SCHWEIZER AIRCRAFT CORP.
ELMHRA, NEW YORK

SOCKET PITCH BEARING LOCKNUT MAIN ROTOR

DRAWING NO. 269T1221
REV. B

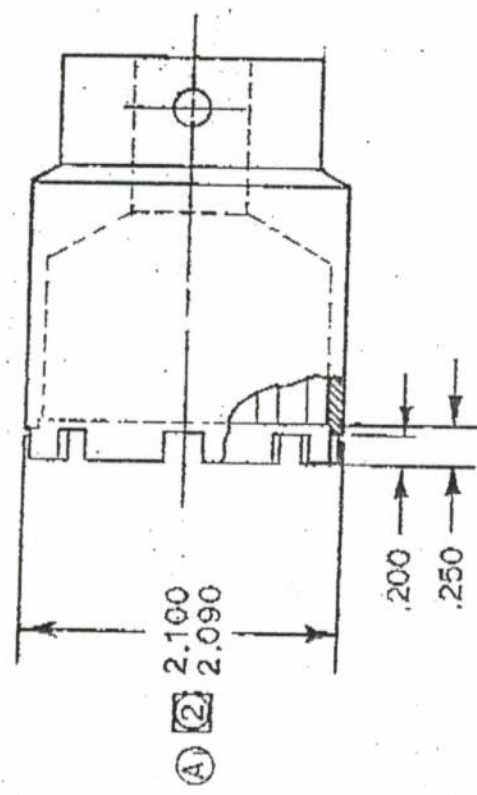
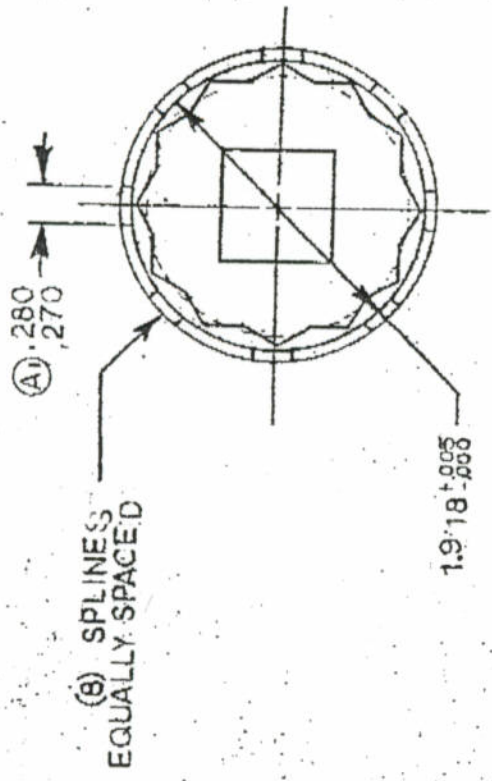
CHG. LTR.	AUTHORITY	DESCRIPTION	BY	CHECKED
A		1. CHANGED DIMS 280/270 WAS 260 ^{+0.003} / _{-0.003} & 2.100/2.090 WAS 2.093/2.083	BFM	4/17/89
B		2. ADDED G/N 3		
		CORRECTED DIM. C/D IN F/N 2 WAS 2.093-2.083	BFM	5/31/89
